UNITED STATES PATENT AND TRADEMARK OFFICE

APPLICATION NO.	FILING DATE	FIRST NAMED INVENTOR	ATTORNEY DOCKET NO.	CONFIRMATION NO.
10/779,683	02/18/2004	Masahiro Kanai	118739	8559
25944	7590	11/01/2005		
OLIFF & BERRIDGE, PLC P.O. BOX 19928 ALEXANDRIA, VA 22320			EXAMINER SOFOCLEOUS, ALEXANDER	
			ART UNIT	PAPER NUMBER
			2824

Office Action Summary	Application No.	Applicant(s)	
	10/779,683	KANAI, MASAHIRO	
	Examiner	Art Unit	
	Alexander Sofocleous	2824

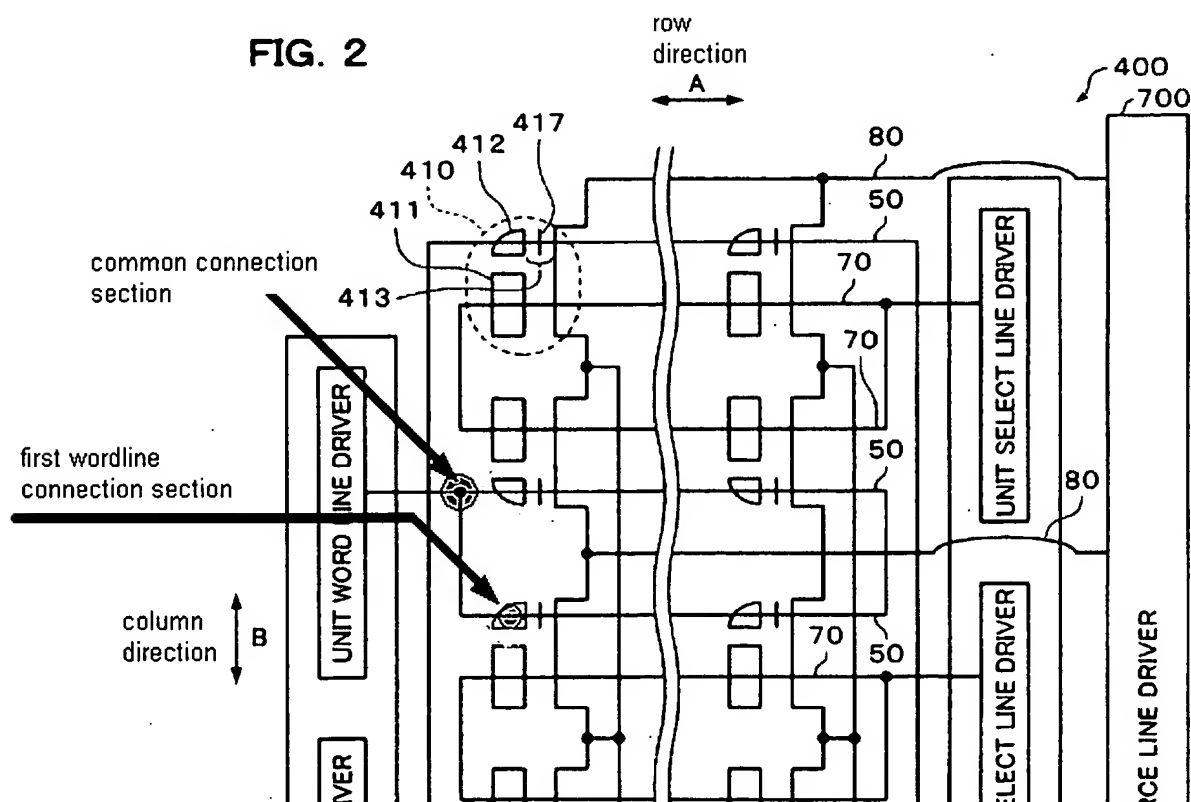
Regarding independent claim 1, Natori shows a nonvolatile semiconductor memory device (Fig. 1 [4000]) comprising: a memory array of memory cells arranged in a row direction and a column direction (Fig. 2 [400]).

The memory cell array includes a plurality of element isolation regions (Fig. 5 [STI]; column 4, lines 27-29).

The memory cell includes a first impurity layer (Fig. 4 [SLD]), a second impurity layer (Fig. 4 [BLD]), a channel between the first impurity layer and second impurity layer (Fig. 3 [unlabeled area between N+ and N+]; see column 3, lines 60-63), a word gate (Fig. 4 [412]) and a select gate (Fig. 4 [411]) disposed to face a channel region (column 1, lines 40-41), and a nonvolatile memory element formed between the word gate and channel region (Fig. 4 [410]; column 1, lines 39-40).

A first wordline connection section connects at least one of a plurality of word gate interconnects, or word lines (Fig. 2 [50]), and at least one of the word gates (Fig. 2 [412]), is disposed above at least one of the element isolation regions (Fig. 5 [412 with respect to STI]).

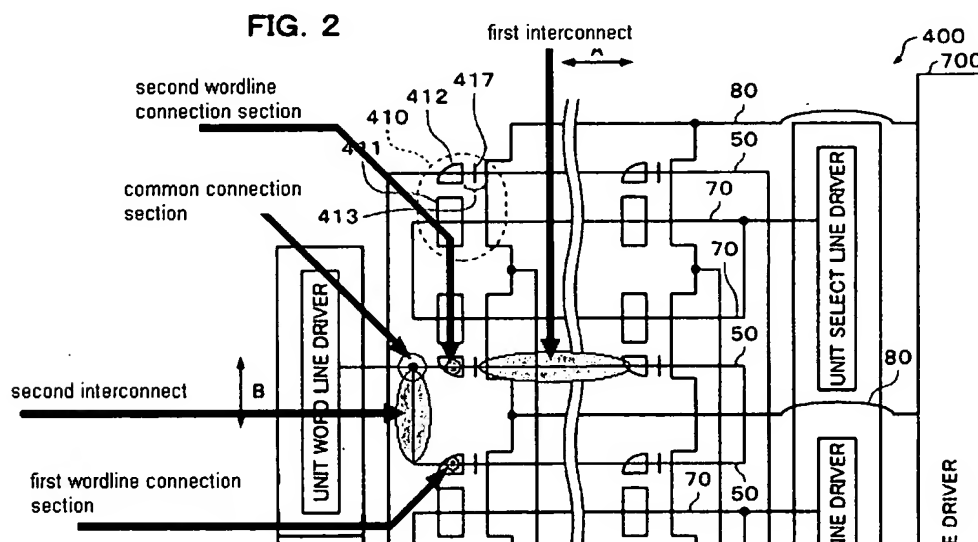
A plurality of common connection sections connect two of the word-gate rows adjacent in the column direction over on of the element isolation regions on which the first wordline connection section is disposed (see Fig. 2 with respect to (Fig. 5 [412 with respect to STI])). See reproduction of Fig. 2 below, as marked up by Examiner to indicate unlabeled points.

Regarding dependent claim 4, Natori shows the first wordline connection section connects at least one of the word gate interconnects (Fig. 2 [50]) with one of the common connection sections (see Fig. 2). See reproduction of Fig. 2 on page 6 of this Office Action, as marked up by Examiner to indicate unlabeled points.

A plurality of common connection sections connect two of the word-gate rows adjacent in the column direction over on of the element isolation regions on which the first wordline connection section is disposed (see Fig. 2 [50] with respect to (Fig. 5 [412 with respect to STI])). See reproduction of Fig. 2 on page 6 of this Office Action, as marked up by Examiner to indicate unlabeled points.

A second wordline connection section which connects one of the common connection sections with the second interconnect is disposed over at least one of the element isolation regions (see Fig. 2[50] with respect to (Fig. 5 [412 with respect to STI]). See reproduction of Fig. 2 below, as marked up by Examiner to indicate unlabeled points.

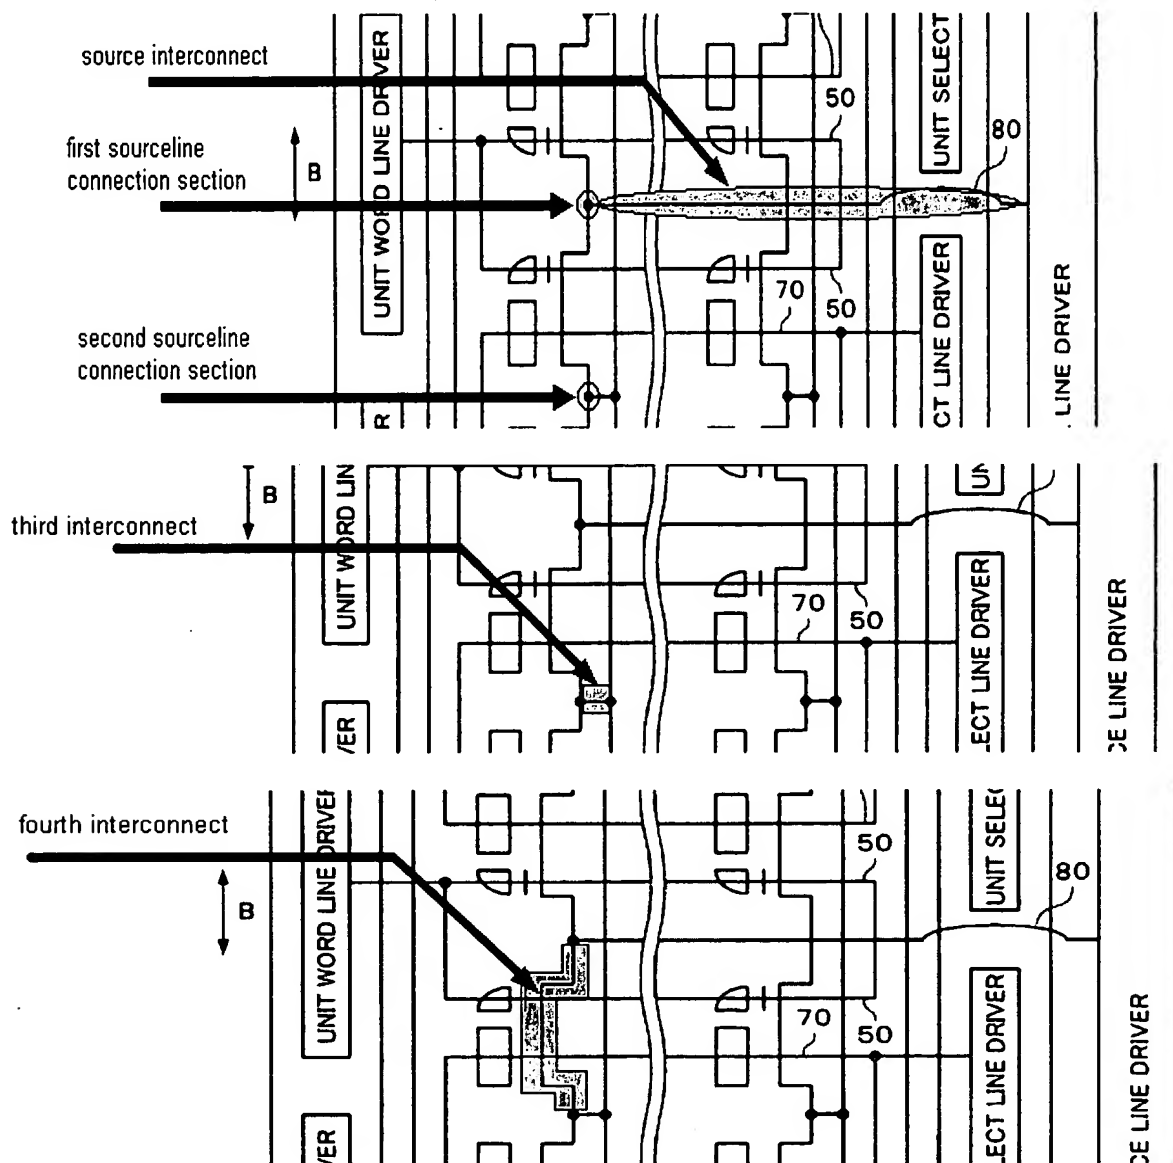
Regarding dependent claim 12, Natori shows at least one source interconnect (Fig. 2 [80]) and a plurality of first source line connection sections (see Fig. 2 [80]) wherein each of the first source line connection sections connects the source

interconnect with the first impurity layer (see Fig. 2 [connection of 80 and 60] with respect to Fig. 5 [connection of 60 and BLD]).
